PLAN COMMISSION STAFF REPORT

Tuesday, January 10, 2023 – 6:00 p.m.

1. **Roll Call**
2. **Approval of the minutes from the December 13, 2022 meeting.**
3. **Discussion regarding last Common Council meetings.**
4. **Site and Architectural Plans for an enclosed patio at Lebnani House, an existing restaurant located at 5051 S. 27 St., submitted by Naser Abdel-Fattah d/b/a Lebnani House, Inc. (Tax Key No. 622-9946-001)**

92nd & COLDSPRING | MULTI-FAMILY DEVELOPMENT
GREENFIELD, WISCONSIN

15 UNIT **COLOR PALETTE A** TYPICAL BUILDING ELEVATIONS

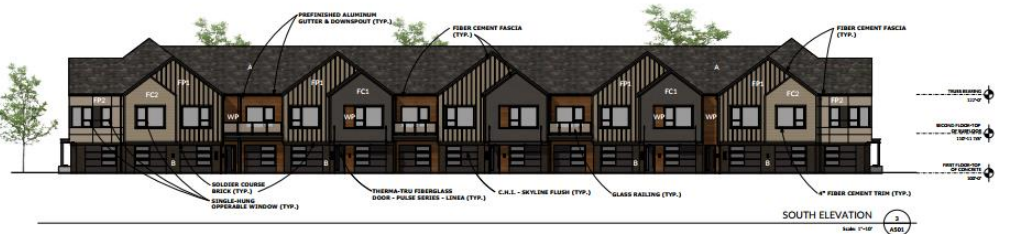
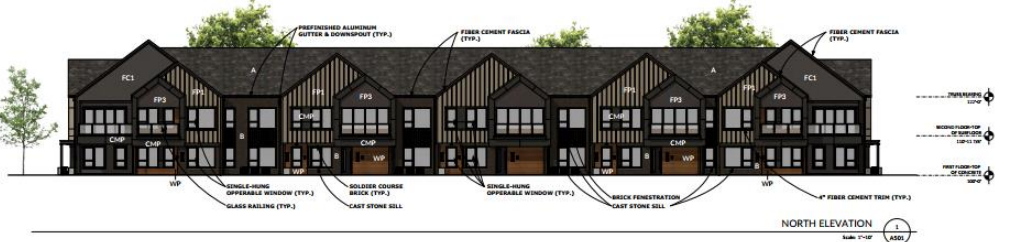
- o **Brick at base of garages:** Brick has replaced the horizontal fiber cement siding (labeled FC1) at the base of the buildings that encompass the garage doors. The cedar-looking Nichiha fiber cement panel material at the base, encompassing the recessed garage doors, remains.

In December the Plan Commission requested more brick at the base of the buildings at the garage door entrances due to snow plowing, shoveling, and salt that can easily damage non-masonry materials. The revised architectural plans show sections where horizontal fiber cement panels (labeled FC1) meet the ground level, being replaced with brick. The cedar-

looking Nichiha fiber cement panels at the base surrounding the recessed garage doors have NOT been replaced.

Staff recommended a variety of coloring between buildings in December, and the January submittal includes two (2) different color pallets throughout the development.

- Revised Site, Landscaping and Architectural Plans being submitted to the Community Development Division to show the following: (a) garage door materials being labeled; (b) cut sheets of building light fixtures; (c) asphalt shingle material details; (d) awning materials being labeled; (e) the mail pavilion building being labeled on architectural elevations sheet; (f) sidewalk along S. 92 St. in the public ROW the entire length of the parcel; (g) required vs. provided parking calculations; (g) floor plan layouts for each building size; (h) perimeter fence details and cut sheet; (i) landscaping coverage percentage; (j) landscaping alterations at the request of the City Forester, if applicable.
- An estimated cost of landscaping and screening being submitted to the Community Development Division for approval.
